**The Secretary of Energy**

Enclosed are the proposed modifications to the Implementation Plan for Defense Nuclear Facilities Safety Board Recommendation 94-1 for the solid residues and solutions stabilization programs at the Rocky Flats Environmental Technology Site. These modifications are consistent with those discussed in your May 27, 1997, meeting with representatives from the Rocky Flats Field Office and the Office of Nuclear Material and Facility Stabilization.

**Rocky Flats Environmental Technology Site  
94-1 Implementation Plan Modification  
May 16, 1997**

Figure 3.1-1

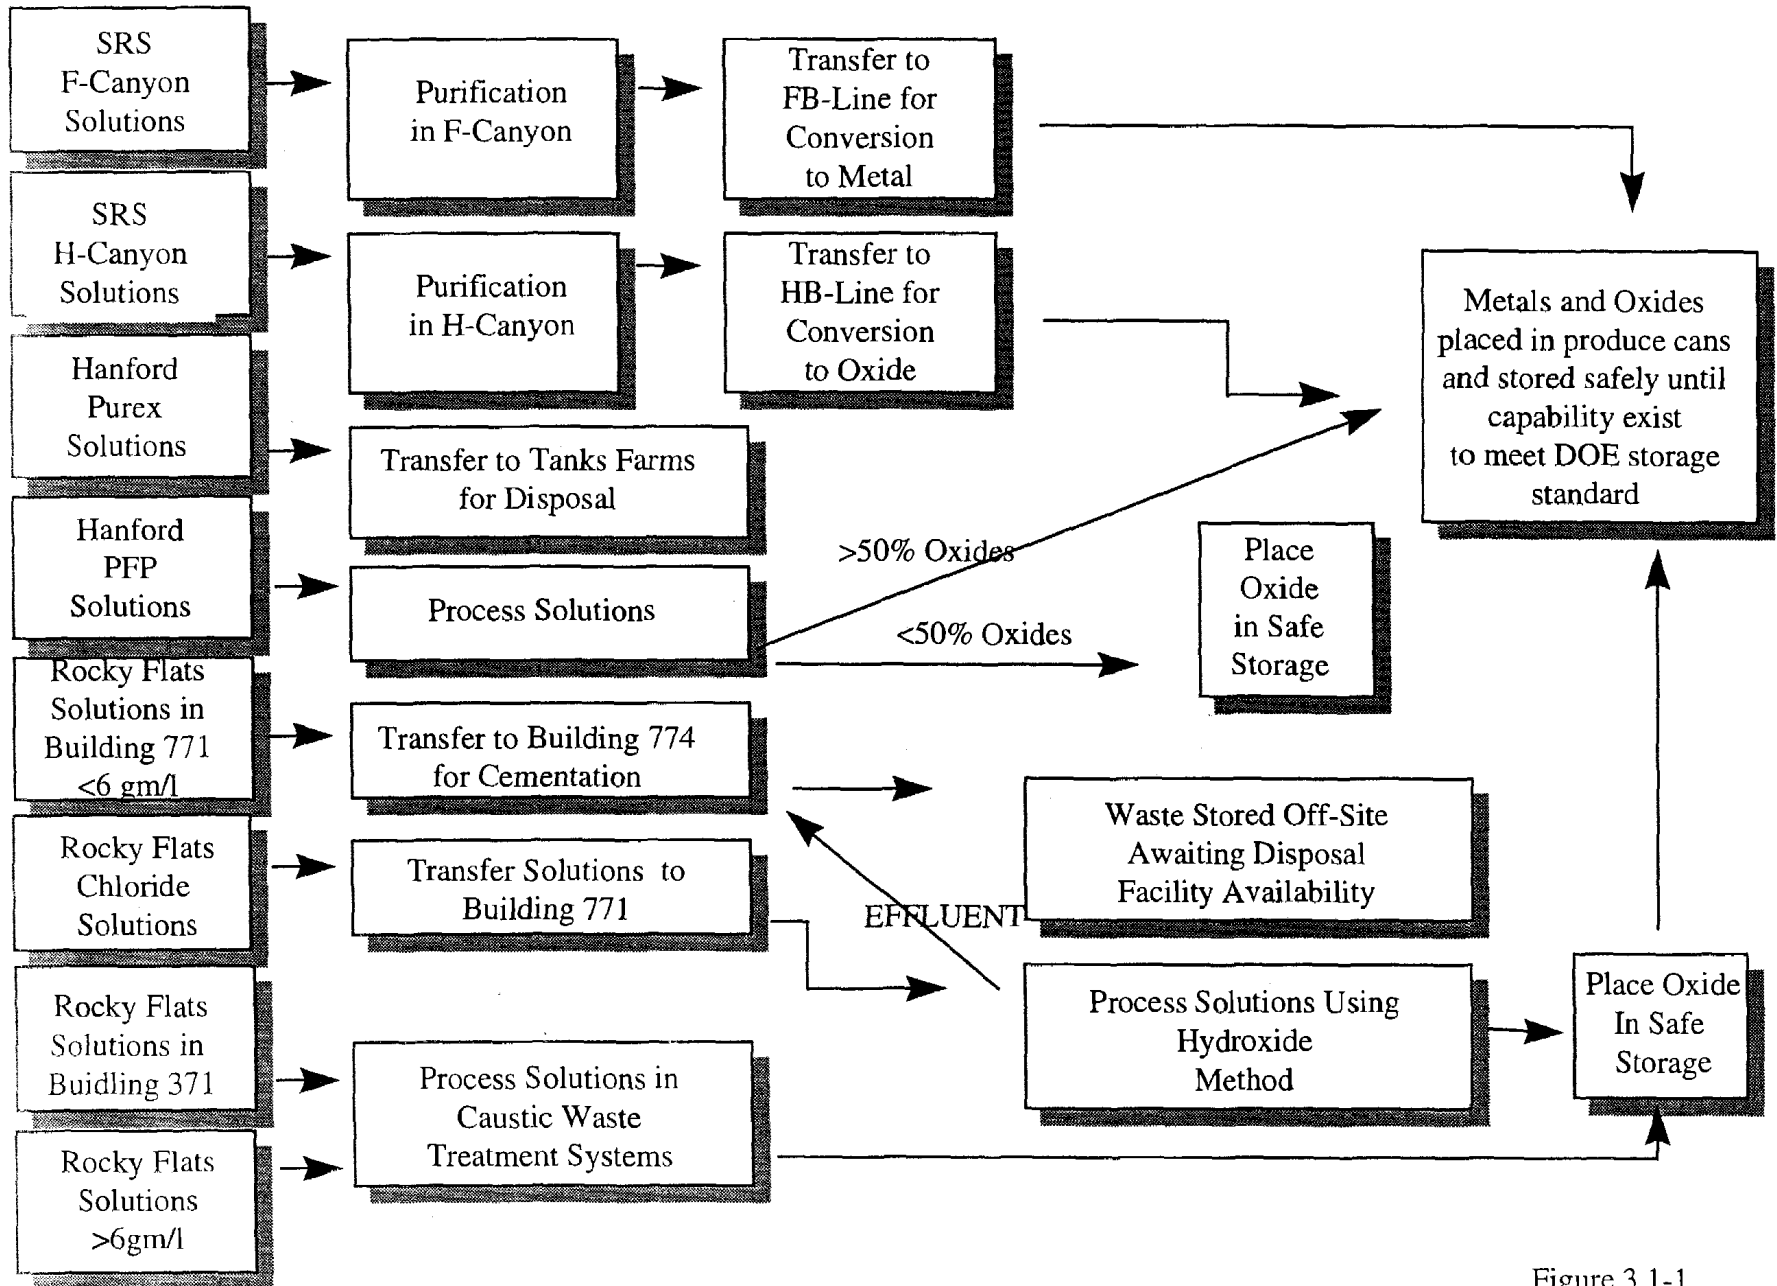
Below is the revision of Section 3.1.2, Rocky Flats solutions, which begins on page 34 of the Implementation Plan. Also attached is a change to Figure 3.1-1. This revision reflects the movement of high level liquids from B771 to B371 for stabilization.

All solutions stored in Building 559, 776/777 and 779 will be transferred to Building 771. Low-level solutions in Building 771 will then be transferred to Building 774 for cementation. Cementing the low-level solutions began in October 1993 and to date 4000 liters have been solidified. The high-level uranium and chloride solutions were processed in Building 771 using a hydroxide precipitation method. The high level plutonium solutions will be drained to bottles and processed through the Caustic Waste Treatment System in Building 371 which is also a hydroxide precipitation process. The precipitate will be calcined and placed in storage and the effluent will be transferred to Building 774 for cementing or Building 374 for further processing in carrier precipitation. All solutions in Building 771 will be removed by September 1998 and the solutions from Building 771 will be stabilized with the Building 371 solutions by June 1999.

The solutions in B371 and remaining high level solutions (>6gm/l) from other buildings will be treated in the Caustic Waste Treatment System. The precipitate will be calcined and placed in storage. The effluent will be transferred to Building 374 for processing through the carrier precipitation. The solutions in Building 371 will be stabilized by June 1999.
